Service Kit 753-0839

CODE: ST-151

DATE: October 7, 1998

SUBJ: Snow Blade 42"

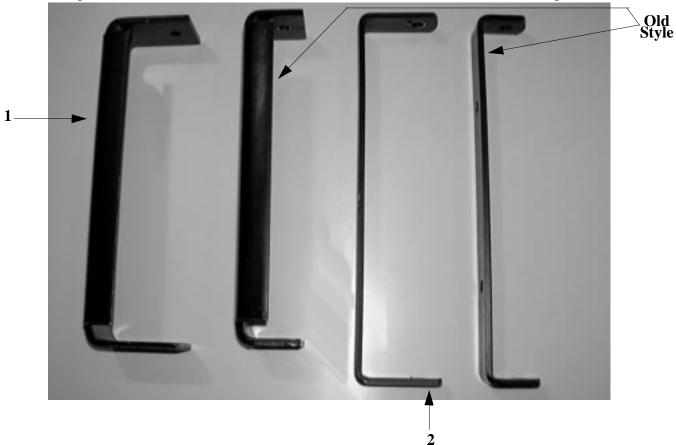
Install Service Kit 753-0839 when replacing lower support bracket AF-24128 or upper support bracket AF-24132. Brackets provided in this kit allow for added clearance between the muffler and the push bar channel.

Ref.	Part		
	No.	No.	Description	Qty.
Ī	1	AF-24388	Lower support Brkt	1
	2	AF-24389	Upper support Brkt	1
